### Community Meeting #2

Held via Zoom on May 12, 2022 with **20 participants**

#### **Concept 1: Most Pond, Least Program**

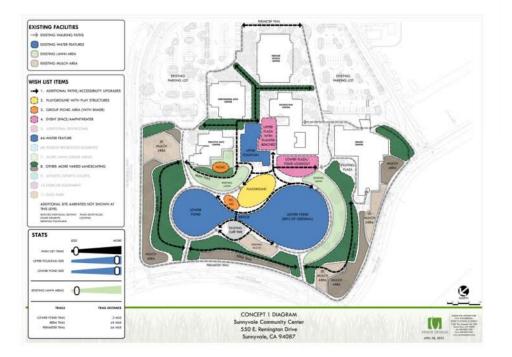
- · Additional trails on the berm
- · Additional picnic areas
- · Less program/ closer to the existing program
- Keeping the upper fountain and the sound of water falling to the lower pond

- · The addition of too much programming
- The large pond still takes up a large amount of space, doesn't help the bird situation, and requires a lot of maintenance
- · The dog park is not needed

- · More walking paths in the central area
- · Active recreation for adults
- Restrooms
- · Picnic areas under trees

#### **Concept 2: Balance of Pond and Program**

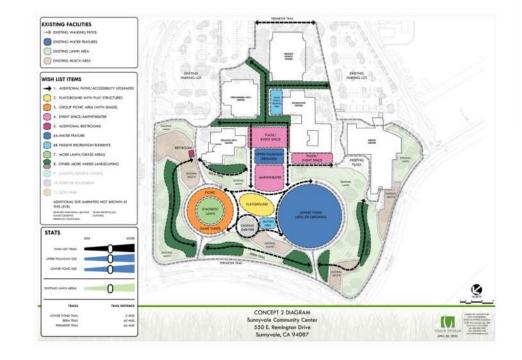
- The location of the amphitheater below the upper fountain and built into the slope
- Restroom location away from central area
- · Trails on the berms
- · Large picnic area

- · Concerns about amphitheater noise
- · Still too much lawn
- · Still too much water
- · Restroom is too far from the central area
- · Concerns about synthetic turf

- · Basketball court
- · Exercise stations
- · Cascading water
- · More shade

#### **Concept 3: No Pond, Most Program**

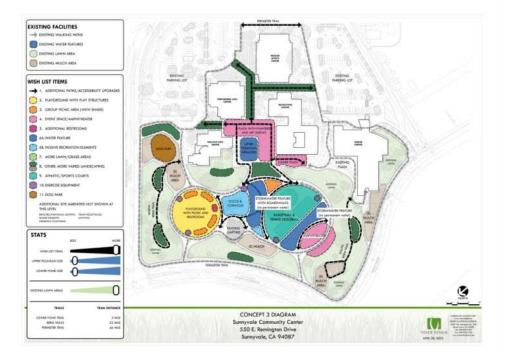
- The location of the amphitheater off Remington Dr and built into the hillside
- The reduction of the water features and inclusion of a seasonal stormwater feature
- · Berm trail
- Multiple picnic areas

- The concept feels too busy/ too much program
- · The dog park is not needed
- · Too much lawn
- · Not the right location for athletics
- · Completely removing the lower pond

- · More native landscaping in lawn areas
- · Shade and seating in the plaza
